Class 2 Permit Modification Request
Revise Volatile Organic Compound Monitoring Procedures

Waste Isolation Pilot Plant
Carlsbad, New Mexico

WIPP Permit Number - NM4890139088-TSDF

April 2015

Figure N-2
VOC Monitoring System Design

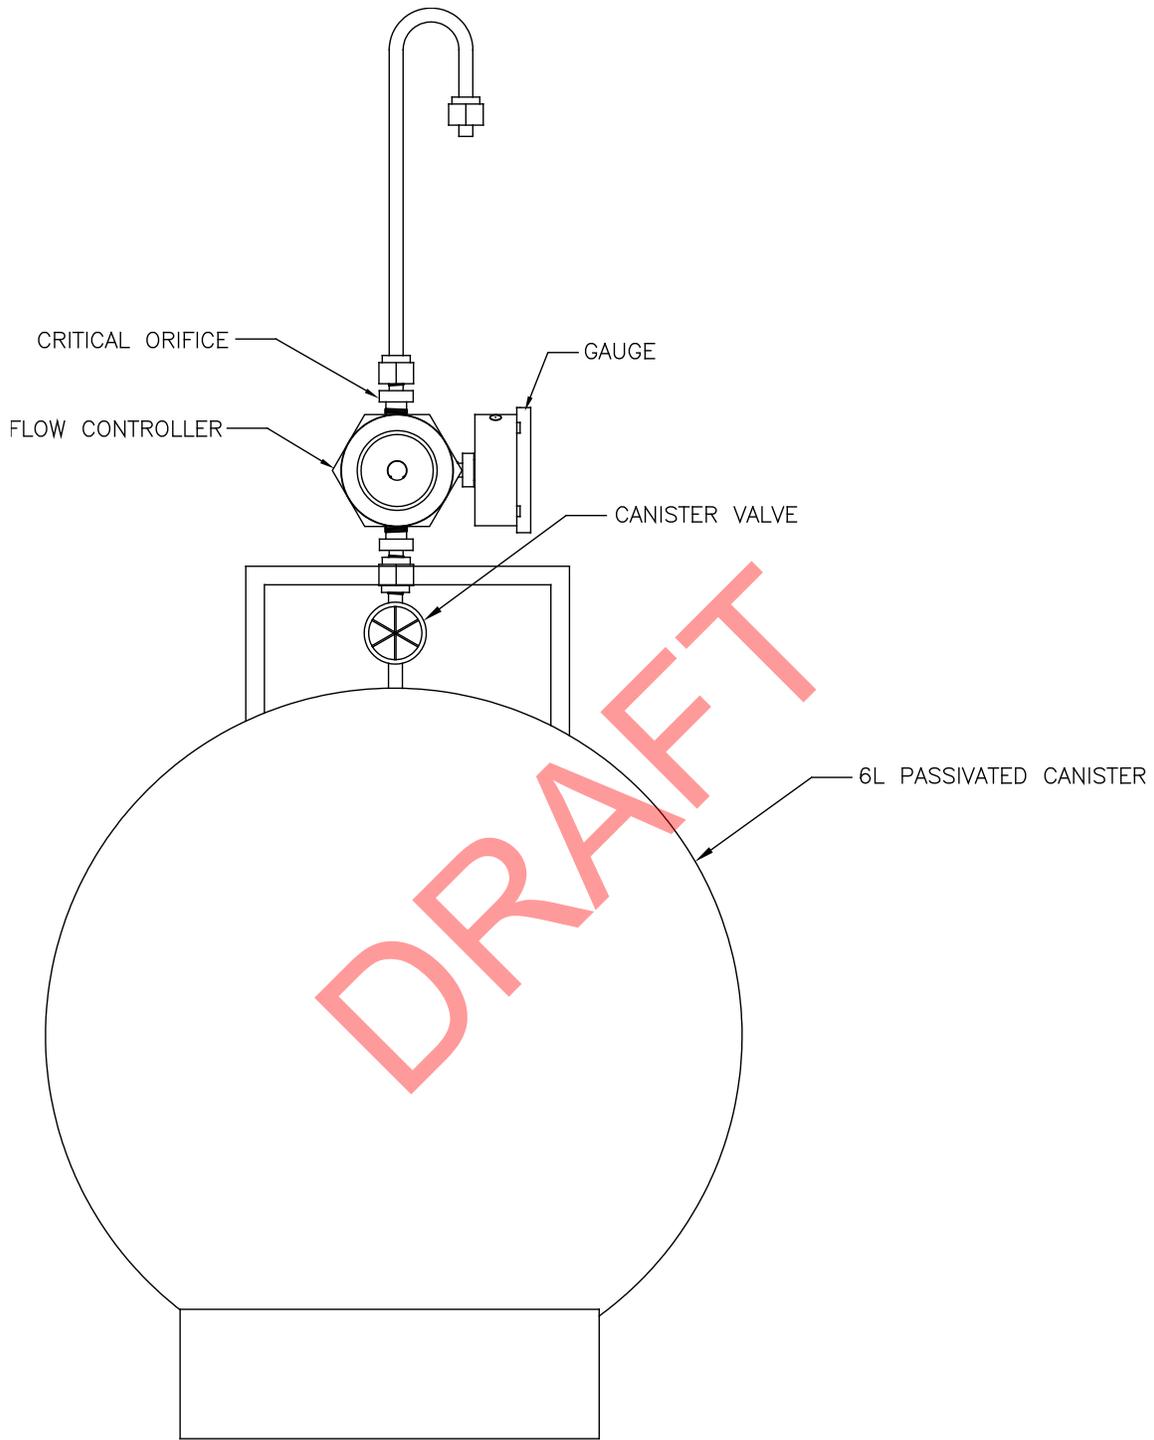
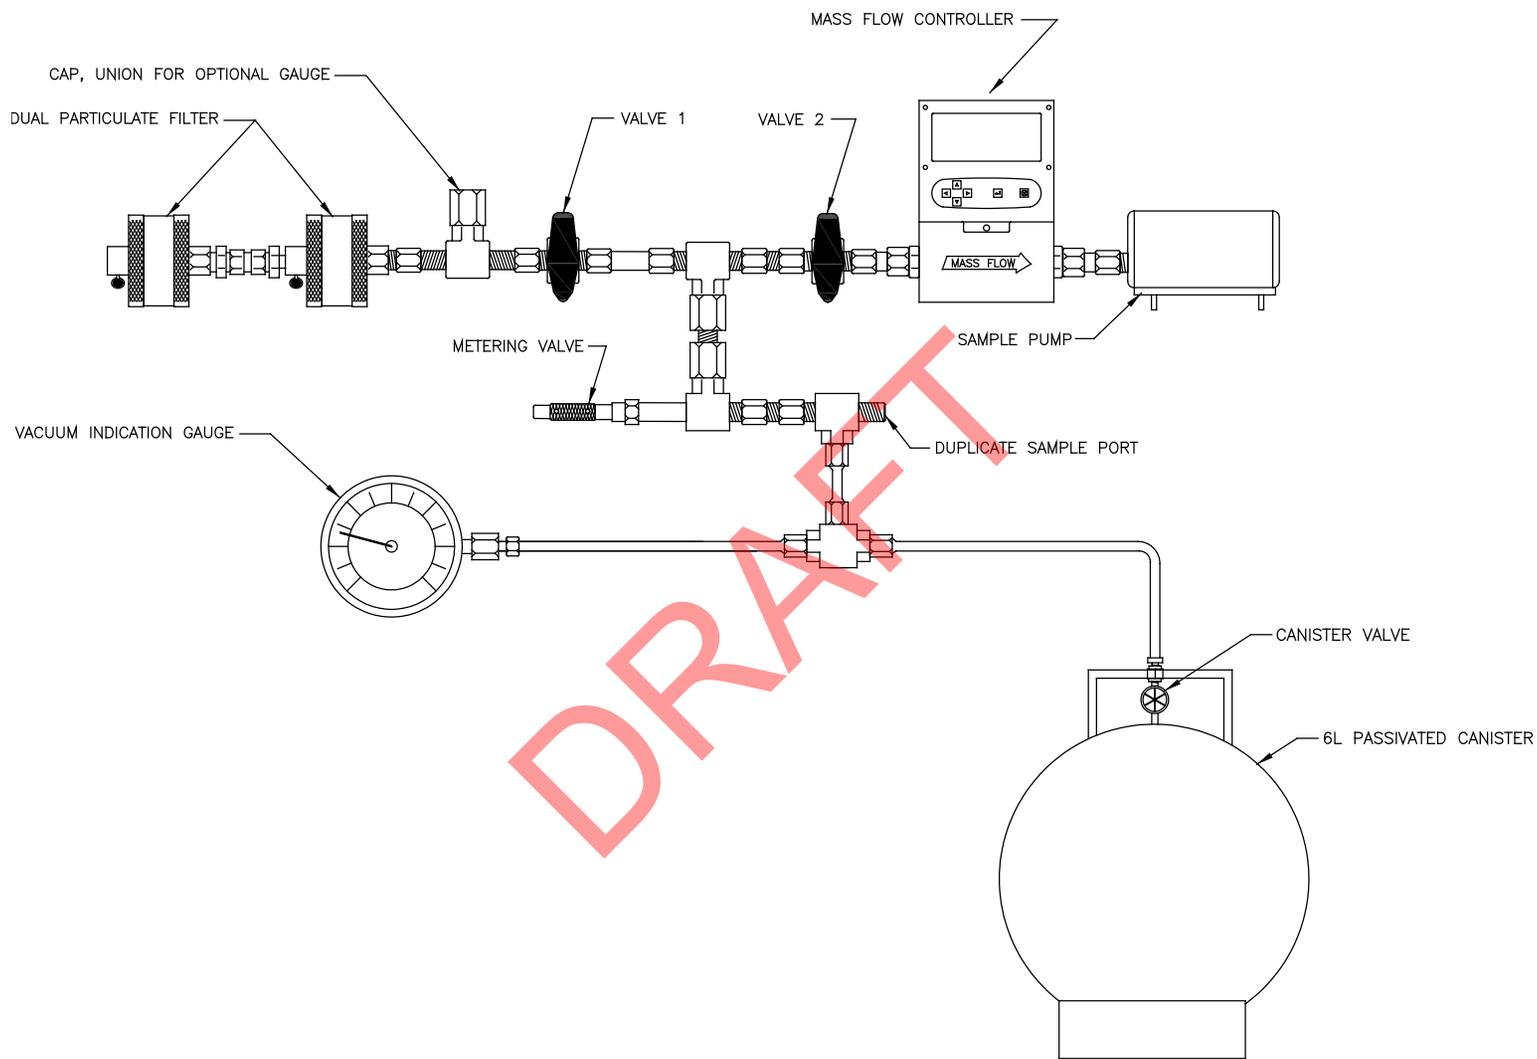
Affected Permit Section	Explanation of Change
	<p>“The sample collection unit for surface VOC samples is a commercially available PASK comprised of components that regulate the rate and duration of air flow into a sample canister. It can be operated either manually, using canister valves, or unattended using a programmable timer.</p> <p>The sample collection unit for disposal room VOC monitoring is a subatmospheric sampling assembly that regulates the rate and duration of air flow into a sample canister. The subatmospheric sampling assembly also allows for purging of sample lines to ensure that a representative sample is collected.</p> <p>Sample collection units will use passivated components for the sample flow path. When sample canisters installed on sample collection units are opened to the atmosphere, the differential pressure causes the sample to flow into the canister at a regulated rate. By the end of each sampling period, the canisters will be near atmospheric pressure. Detailed instructions on sample collection will be given in SOPs. A conceptual diagram of a VOC sample collection unit is provided in Figure N-1”</p>

Sample collection units will use passivated components for the sample flow path. When sample canisters installed on sample collection units are opened to the atmosphere, the differential pressure causes the sample to flow into the canister at a regulated rate. By the end of each sampling period, the canisters will be near atmospheric pressure. Detailed instructions on sample collection will be given in SOPs. A conceptual diagram of a VOC sample collection unit is provided in Figure N-1.

A conceptual diagram of a VOC sample collection unit is provided in Figure N-2. Such units will be used at monitoring Stations VOC-A and VOC-B and at sampling locations for disposal room measurements. The sampling unit consists of a sample pump, flow controller, sample inlet, inlet filters in series to remove particulate matter, vacuum/pressure gauge, electronic timer, inlet purge vent, two sampling ports, and sufficient collection canisters so that any delays attributed to laboratory turnaround time and canister cleaning and certification will not result in canister shortages. Knowledge of sampler flow rates and duration of sampling will allow calculation of sample volume. The set point flow rate will be verified before and after sample collection from the mass flow indication. Prior to their initial use and annually thereafter, the sample collection units will be tested and certified to demonstrate that they are free of contamination above the reporting limits of the VOC analytical method (see Section N-5). Ultra-high purity humidified zero air will be pumped through the inlet line and sampling unit and collected in previously certified canisters as sampler blanks for analysis. The cleaning and certification procedure is derived from concepts contained in the EPA Compendium Method TO-15 (EPA, 1999).

Figure N-3
Disposal Room VOC Monitoring

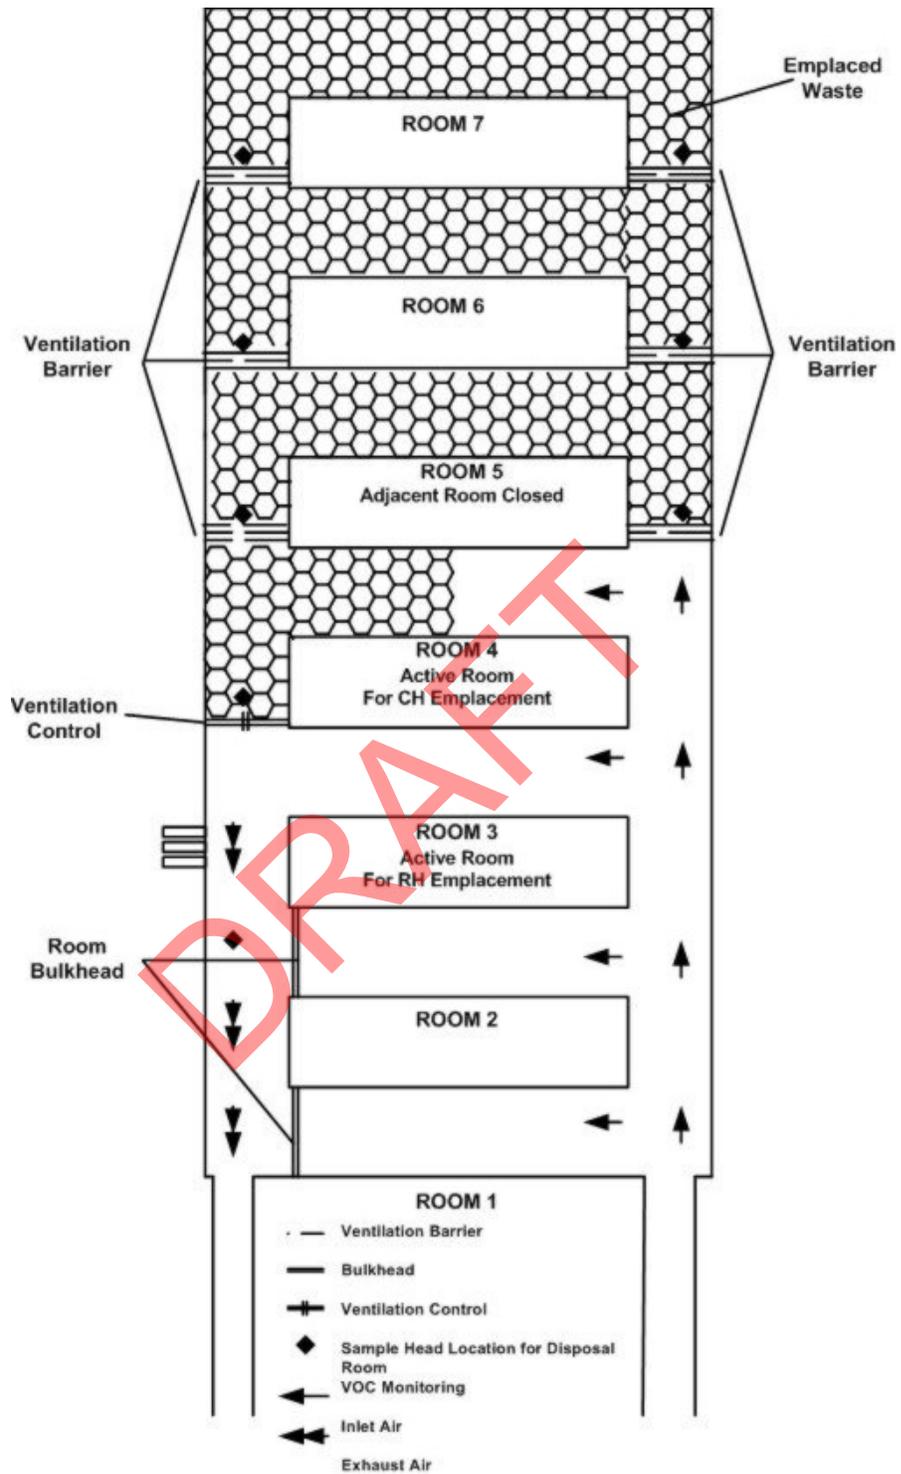
Affected Permit Section	Explanation of Change
	<p>Added "Surface" before Monitoring" in heading row.</p> <p>Made the following changes to the Required Repository Surface Monitoring MRL (ppbv) column by row.</p> <ul style="list-style-type: none"> Replaced "2" with "0.2" Replaced "2" with "0.2" Replaced "2" with "0.2" Replaced "5" with "0.2" Replaced "2" with "0.2" Replaced "5" with "0.2" Replaced "2" with "0.2" Replaced "5" with "0.2" Replaced "5" with "0.2" <p>Added one row "Trichloroethylene" "60 to 140" "25" "35" "0.2" "500" "95"</p> <p>Added ", allowances for conditions that may produce non-representative RPD values will be specified in SOPs" to RPD note.</p>
Attachment N, Figures	<p>Deleted Figure N-1.</p> <p>Replaced Figure N-2 with a new drawing and renumbered Figure N-2 to Figure N-1.</p> <p>Replaced Figure N-3 with updated drawing and renumbered Figure N-3 to Figure N-2 and added "Typical" to beginning of the figure title and "Locations" to the end of the title.</p> <p>Replaced Figure N-4 with updated drawing and renumbered Figure N-3 to Figure N-2 and replaced "VOC" with "Disposal Room" in figure title.</p>

Figure N-3
Disposal Room Sample Head Arrangement

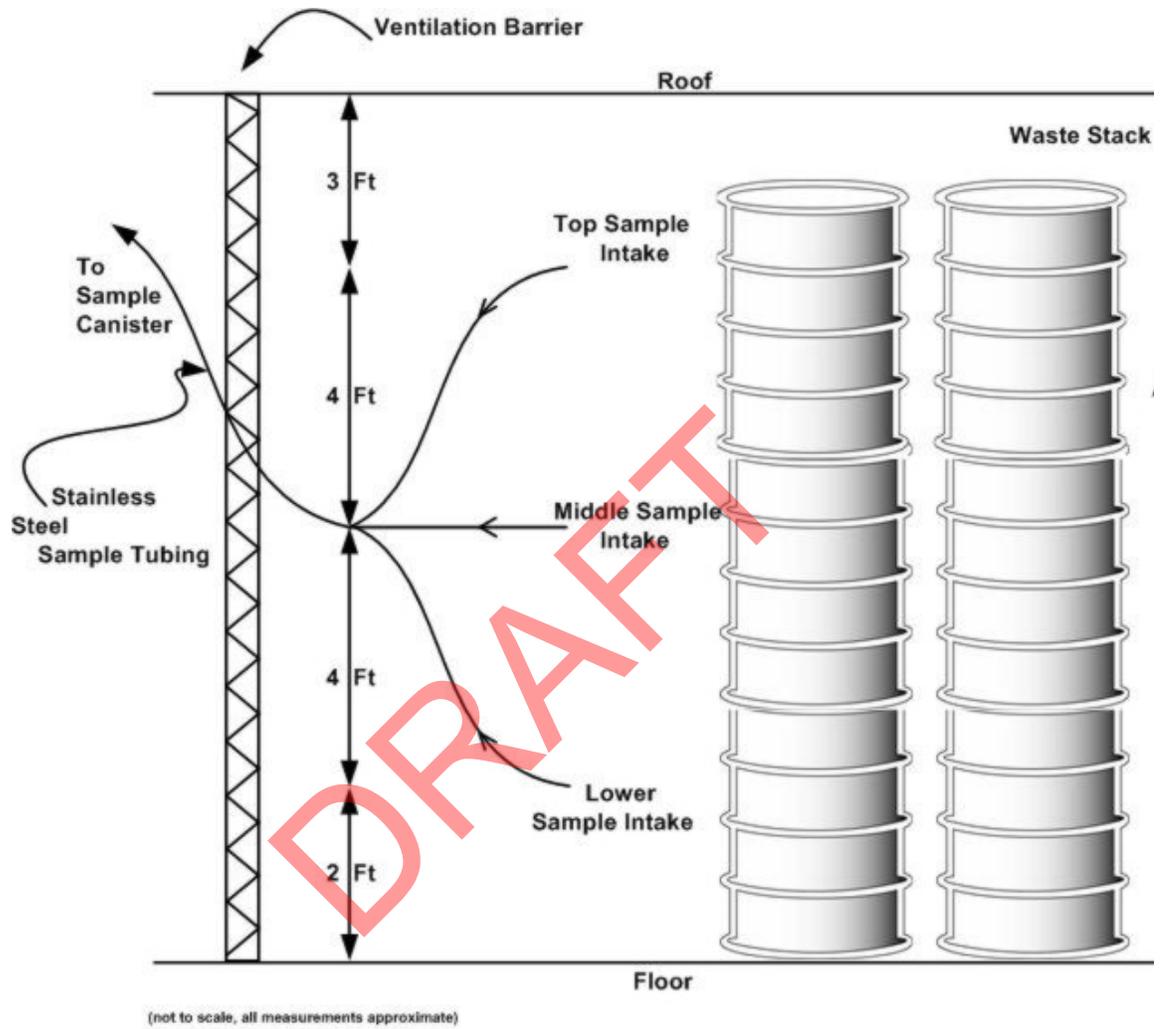
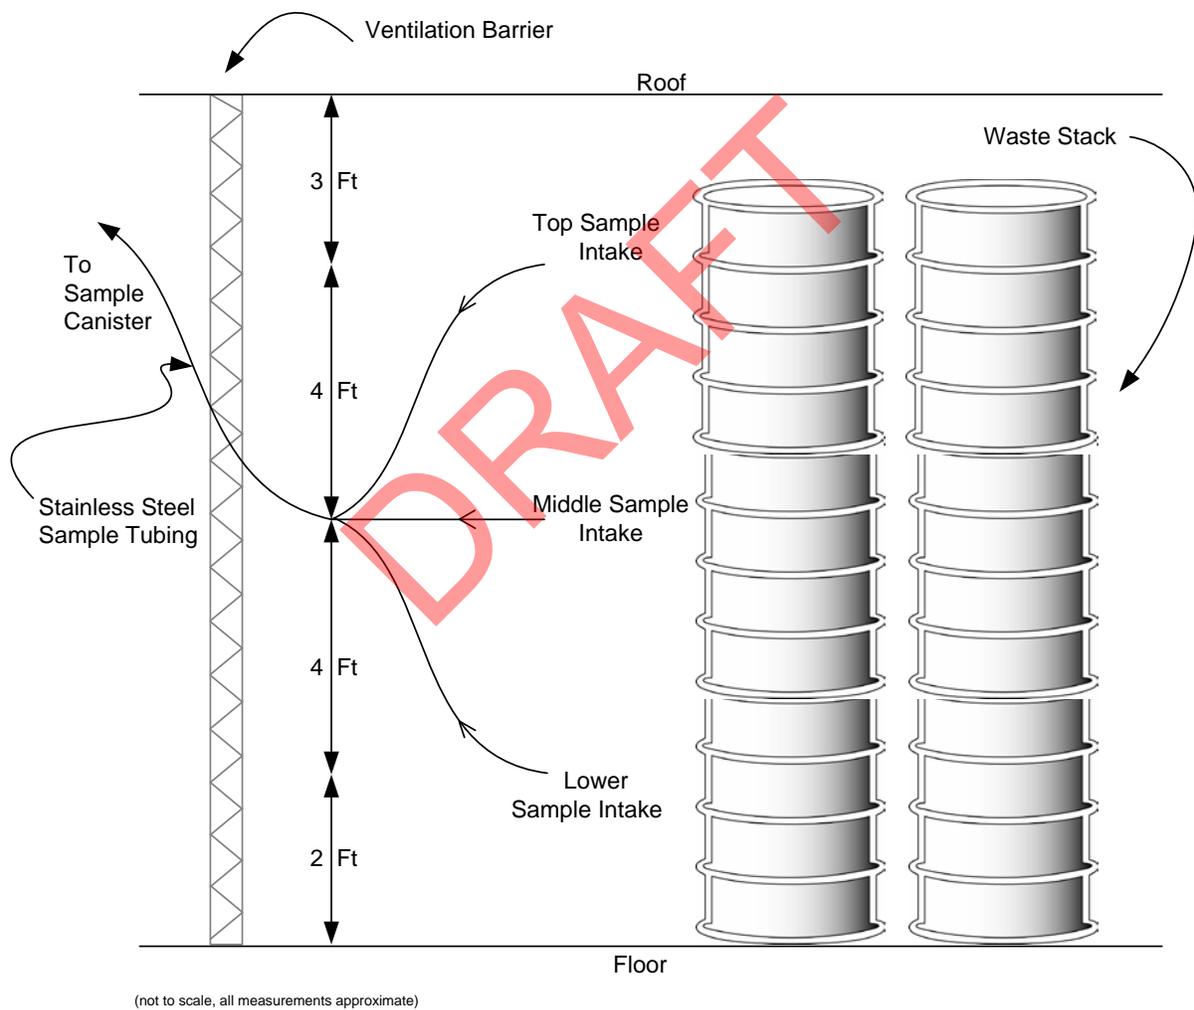
Affected Permit Section	Explanation of Change																																										
	<p>Moved a period into the parenthesis after Operations. (Editorial change)</p> <p>Replaced “4” with “2” in last paragraph.</p> <p>Added a comma after “Program” to read “Program,” (Editorial change)</p>																																										
Attachment N, Table of Contents	<p>Replaced “SUMMA®” with “Sample” in title of “ N-4a(1) (Editorial change)</p> <p>Replaced “Volatile Organic Compound Canister Samplers” with “Sampling Collection Units” in title or N-4a(2)</p> <p>Deleted “Sampler” and added “of Sample Collection Units” to title of N-4d.</p>																																										
Attachment N, List of Tables	<p>Replaced “A” with “C” and “B” with “D” in title of Table N-1.</p> <p>Added “VOC” to title of Table N-1.</p>																																										
Attachment N, List of Figures	<p>Deleted Figure N-1 from list of figures.</p> <p>Renumbered Figure N-2 to Figure N-1.</p> <p>Renumbered Figure N-3 to Figure N-2 and added “Typical” to beginning of the figure title and “Locations’ to the end of the title.</p> <p>Renumbered Figure N-4 to Figure N-3 and replaced “VOC” with “Disposal Room” in figure title.</p>

Figure 2. Contours of Annual Impact Concentrations (in $\mu\text{g}/\text{m}^3$)
 From Generic 1 lb/hr Emission Rates
 Assuming 60,000 cfm

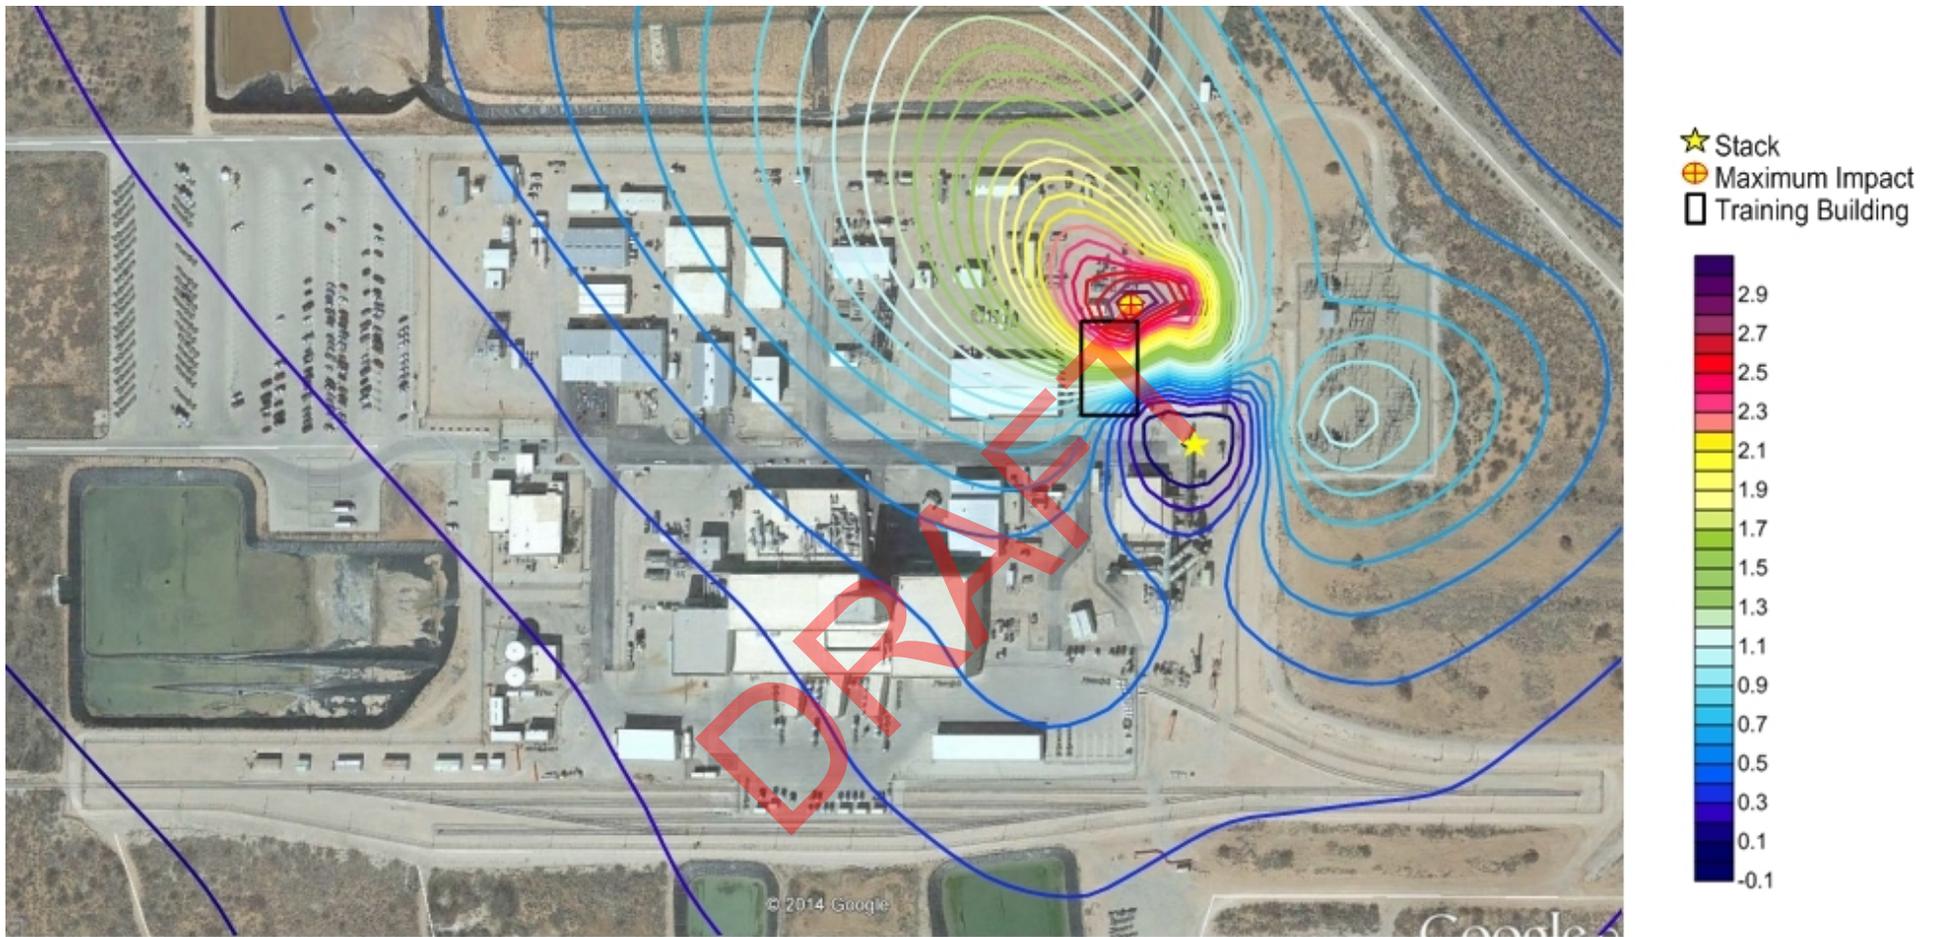
Figures 2 and 3 show impact contours and the location of maximum on-site impact for the 60,000 cfm (1,700 m³/min) and 114,000 cfm (3,200 m³/min) scenarios, respectively. As shown in the figures, the predicted location of maximum on-site impact is at the northeast corner of the Training Building for the 60,000 cfm scenario and the northwest corner of the building for the higher flow rate scenario. Of significance for the above-ground monitoring program, the Training Building is still the closest occupied building to the predicted location of maximum on-site impact. However, the Training Building monitor (Figure 1) is currently located on the southeast side of the building where predicted impacts are significantly lower (see impact contours in Figures 2 and 3) than the maximum predicted impact.

The south fenceline monitor, placed to measure background VOC concentrations (see Figure 1 for monitor location), could measure concentrations that are influenced by vent emissions (see annual impact contours on Figures 2 and 3). Although located upwind of the vent most of the time, there will be periods when the wind blows southeast in the direction of the monitor. The monitor WQSP-4 is further from the vent in an upwind direction and therefore measurements collected there better represent background concentrations of VOCs in the vicinity of the WIPP facility.

1. Continue the current above-ground monitoring program for the time-being with these adjustments:
 - a. Move the Training Building sample location to adjacent to the air intake on the west side of the building. If it is important to demonstrate that the monitor location is adequately conservative, the predicted location of maximum on-site impact under the 60,000 cfm scenario (Figure 2) and under the 114,000 cfm scenario (Figure 3) are better locations than the current location on the southeast side of the building.
